PROPOSED WORDING

BEAVER VALLEY - UNIT 1

ATTACHMENT B Safety Evaluation

Proposed Change Request No. 86, Revision 3 amends the Beaver Valley Power Station, Unit No. 1 Technical Specifications, Appendix A to address the NRC comments identified by letter dated March 13, 1984.

3/4 3-21 PROPOSED WORDING

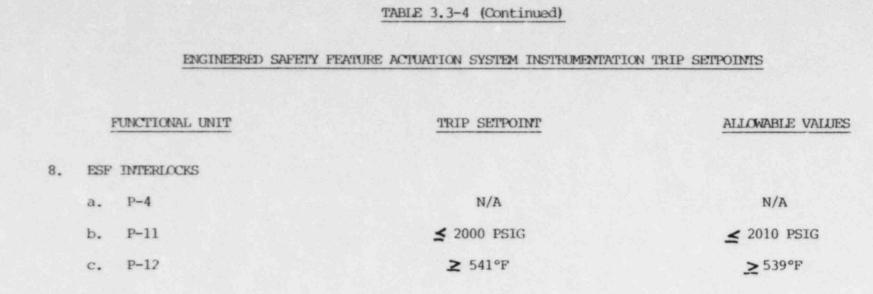
page 3/4 3-21 Delete the Engineered Safety Feature Interlocks in accordance with NRC staff recommendation 1, since the interlocks have been incorporated into the applicable tables and now more appropriately indicate the conditions under which protective functions may be bypassed as well as those under which manual bypasses are automatically removed. Action 36, 37. and 38 have been added to reflect the changes to Table 3.3-3.
